NORTHEAST UTILITIES

August 29, 1983
Docket No. 50-423
B10878

Millstone Nuclear Power Station, Unit No. 3
Response to Selected Requests for Additional Information

FIGURE Q430.136-1
 OPERATING CONTROL SYSTEM FOR
 REHEAT TURBINE-EHC MARK II
 MILLSTONE NUCLEAR POWER STATION
 UNIT 3
 FINAL SAFETY ANALYSIS REPORT

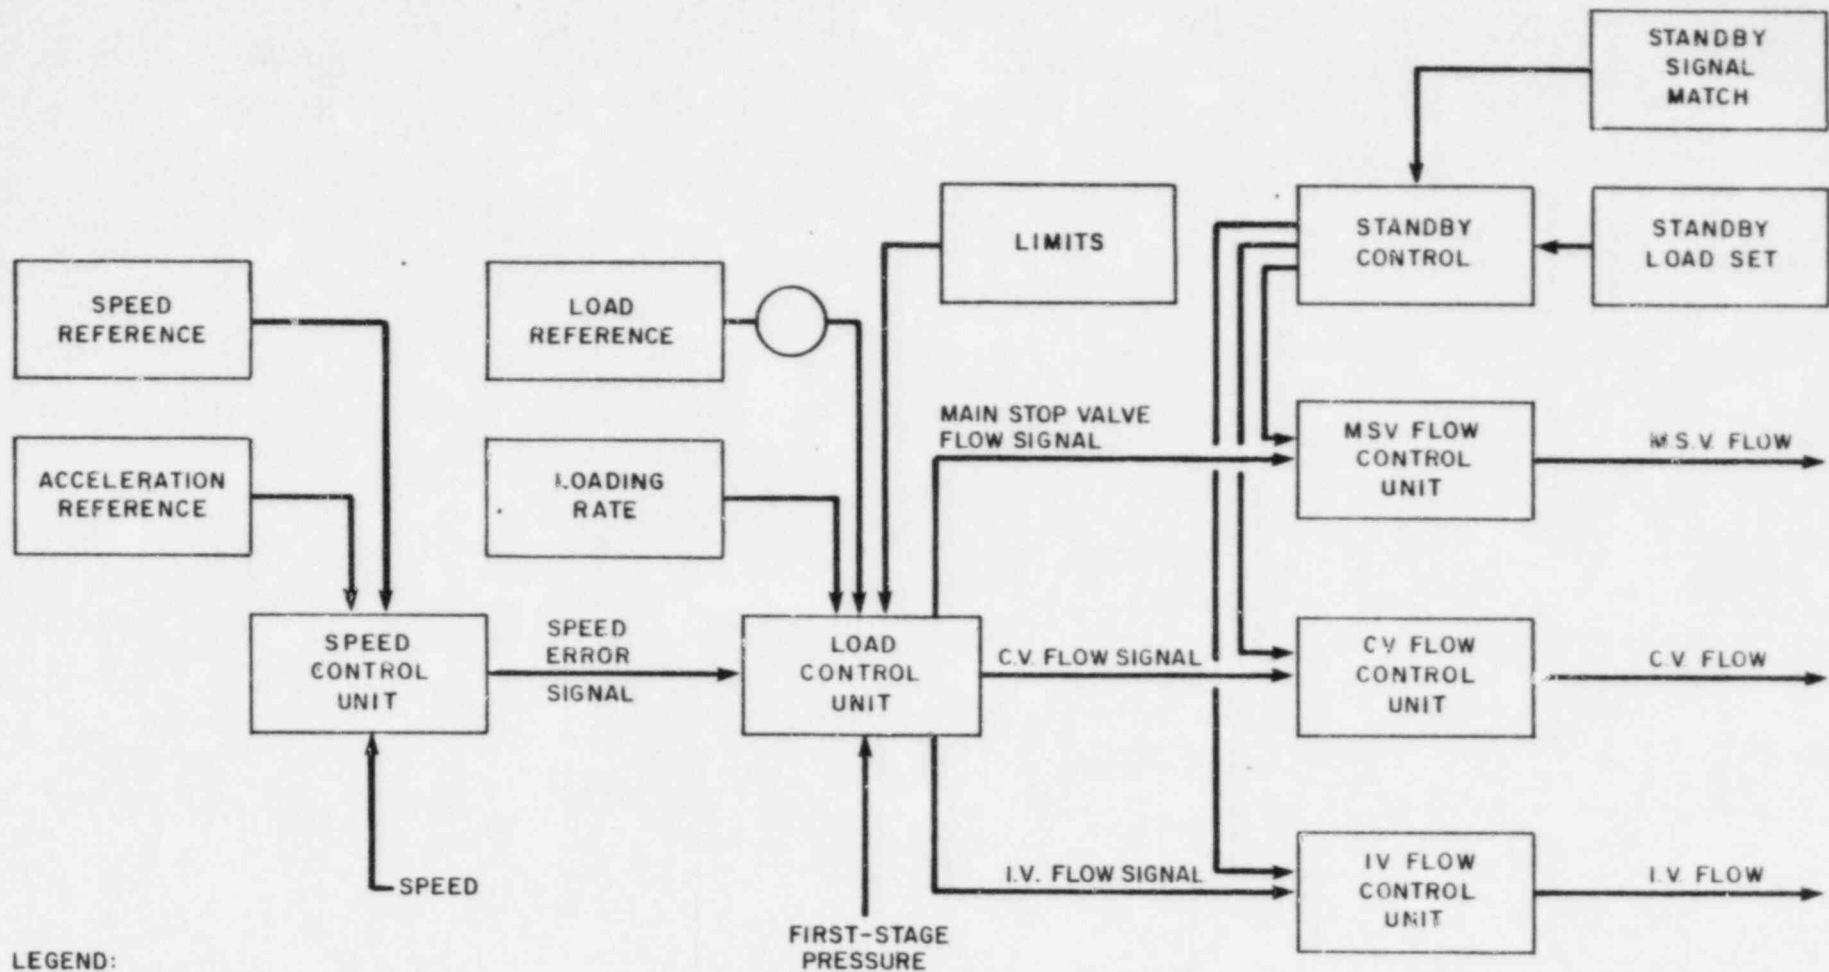
Expand your discussion of the turbine speed control and overspeed protection system. Provide additional explanation of the turbine and generator electrical load following capability for the turbine speed control system with the aid of system schematics (including turbine control and extraction steam valves to the heaters). Tabulate the individual speed control protection devices (normal, emergency, and backup), the design speed (or range of speed) at which each device brings operation to perform its protective function (in terms of percent of normal turbine operating speed). In order to evaluate the adequacy of the control and overspeed protection system, provide schematics and include identifying numbers to valve and mechanisms (mechanical and electrical) on the schematics. Describe in detail, with references to the identifying numbers, the sequence of events in a turbine trip including response times, and show that the turbine stabilizes. Provide the results of a failure mode and effects analysis for the overspeed protection systems. Show that a single steam valve failure cannot disable the turbine overspeed trip from functioning.

The General Electric Company turbine's Mark II electro-hydraulic control (EHC) system incorporates the circuitry and equipment required to provide the following basic turbine control functions:
